METZGER PARK BASEBALL & SOFTBALL FIELDS

ADDENDUM #2

September 14, 2023

THRASHER PROJECT #101-T30-11111

UTILITY PLAN-2

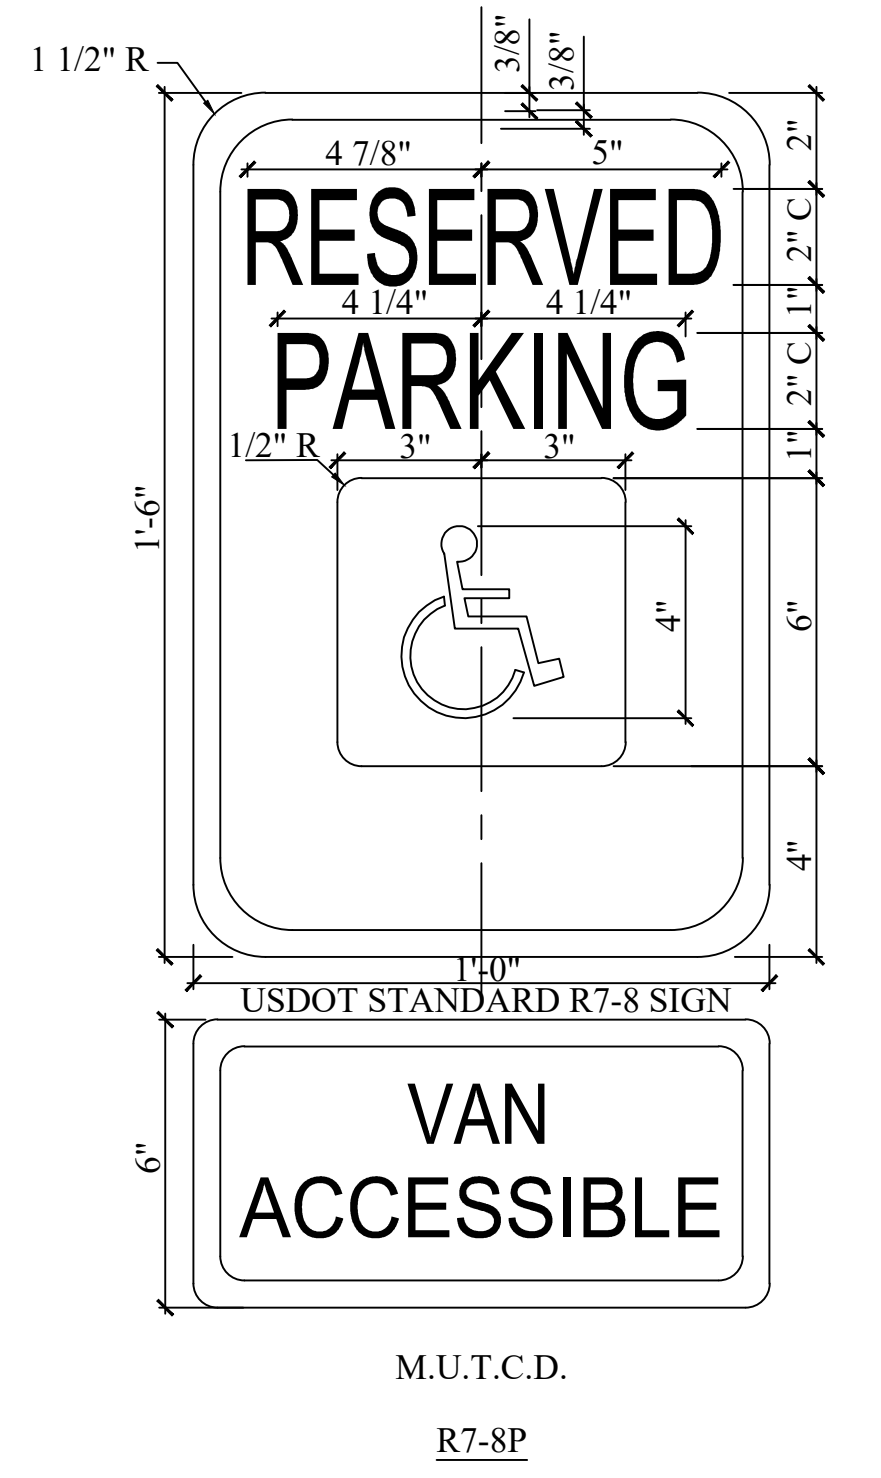
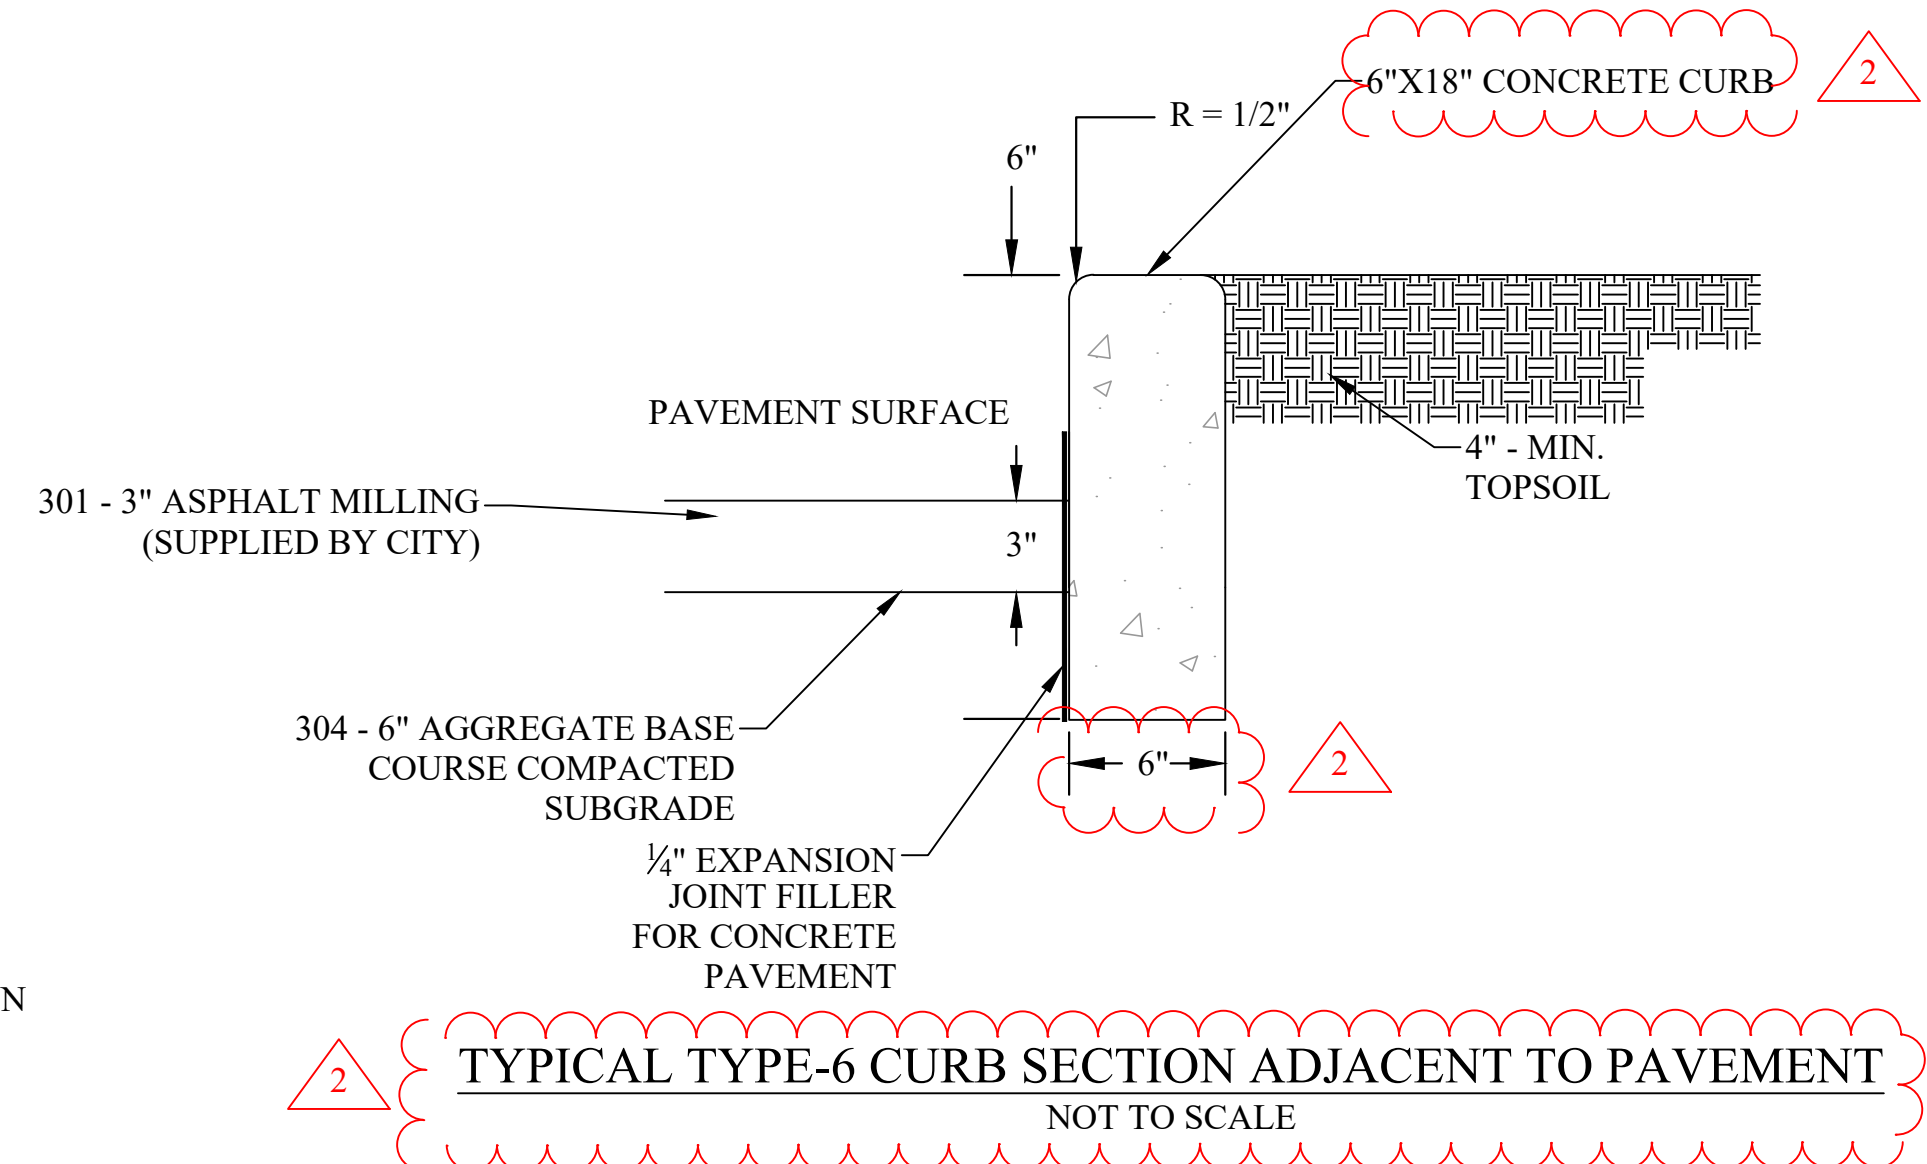
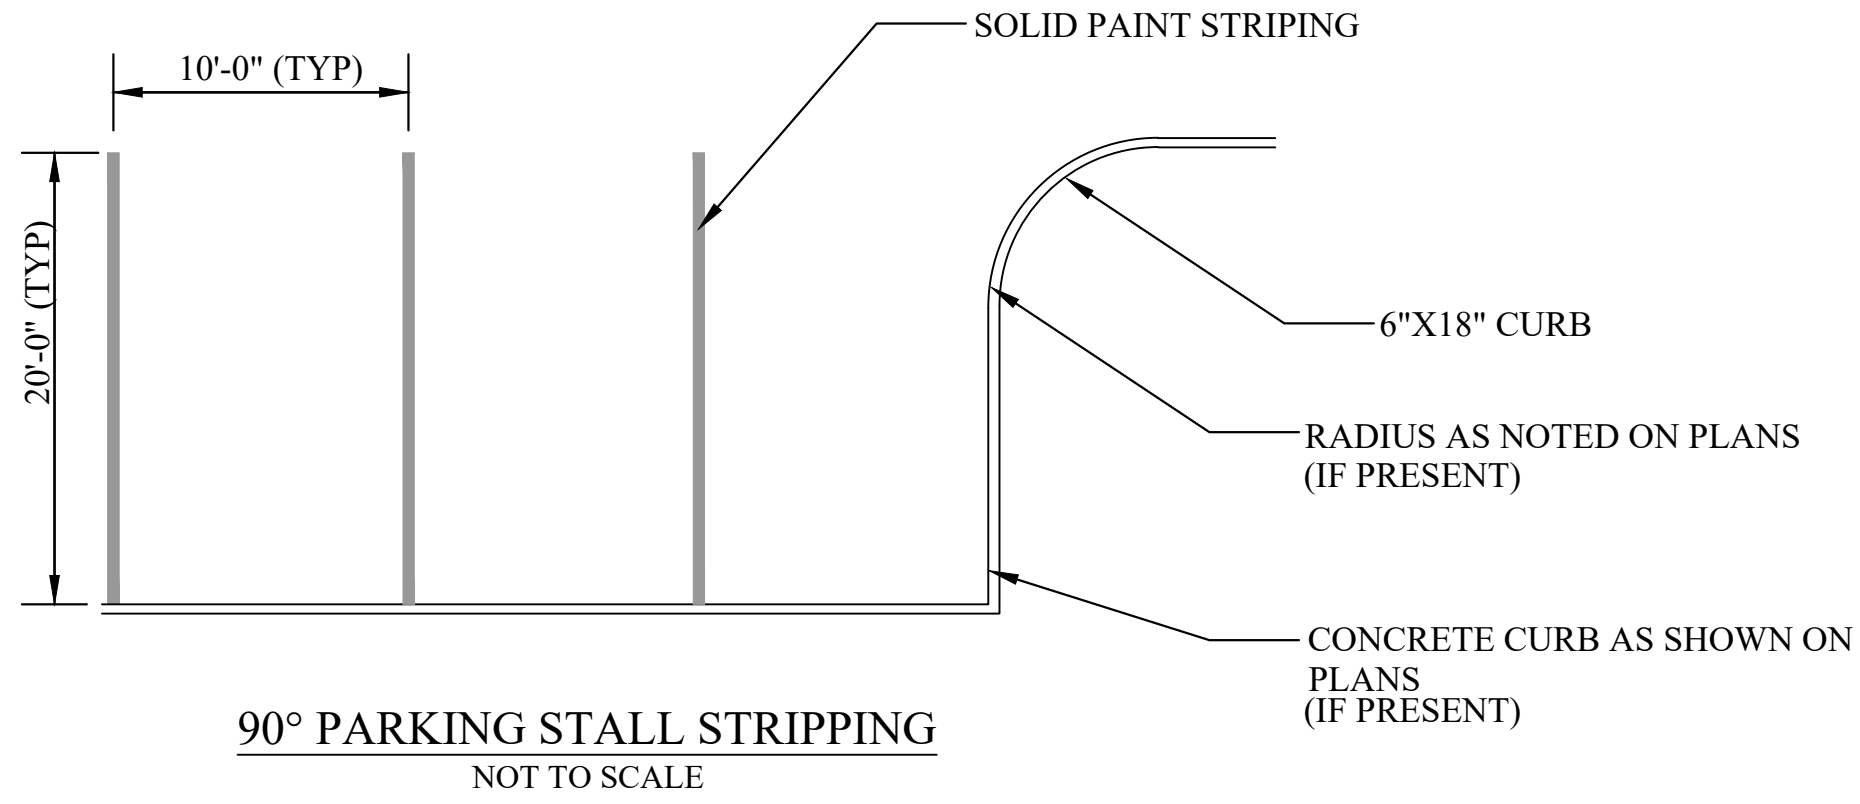
NO.	BY	DATE	DESCRIPTION
01	FMK	09/14/2023	ADDENDUM - 2 - REVISED NOTE ON THIS SHEET.

THE PARKING LOT SCOPE OF WORK IS, THE CONTRACTOR IS TO REMOVE THE ASSUMED 12" OF TOPSOIL AND STOCKPILE IT AS SHOWN ON THE PLANS, GRADE, AND COMPACT THE SUBGRADE, INSTALL THE 6"X18" CURB, PLACE AND COMPACT THE 304 AGGREGATE, SUPPLY THE TRUCKING FOR THE CITY SUPPLIED MILLINGS (OFF SITE), TRANSPORT THE CITY SUPPLIED MILLINGS, PLACE AND COMPACT THE CITY SUPPLIED MILLINGS.
